T.I. No.: 2022-11 Update:	Thema: Change of material - brewing unit 16g „brown“
-------------------------------------	---

Date: 12.04.2022	Priority	Need for action
Affected machines: SC Club	High	As soon as possible
From serial number: -	Medium	On next visit to the machine
As of date: immediately	x Low	x FYI only

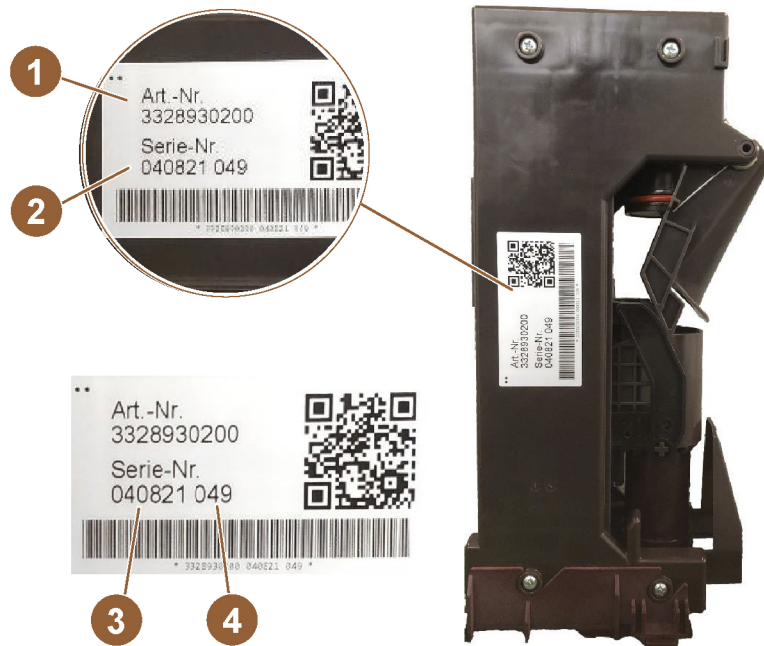
The previously used plastic material of the "brown" brewer, which was used for all brown brewer parts, can no longer be provided by the supplier and therefore the change to a new plastic material is required.

Identifying feature brewer „brown“ with new plastic material

Individual brewer parts or a complete brewer "brown" made of new plastic material can be recognized by the following features:

- > Slightly reddish color which differs from the brown of the original „brown“ brewer
- > Brewer serial number (glued-on type plate)

Notice: Do not confuse with the "red" brewer from SAG!

In order to assure this precision also after repairs and to avoid mixing of individual brewer parts made of the previous plastic material on brewers made of new plastic material, a spare part kit is introduced.

The spare part kit may be used for ALL "brown" brewers.

However, individual brewer spare parts which are made of the old plastic material must NOT be fitted in "brown" brewers made of the new plastic material (as of brewer serial number - 035021 006).

Upper spout piston (with brew panel and piston o-ring)	Brewing cylinder	Lower piston (with piston o-ring)
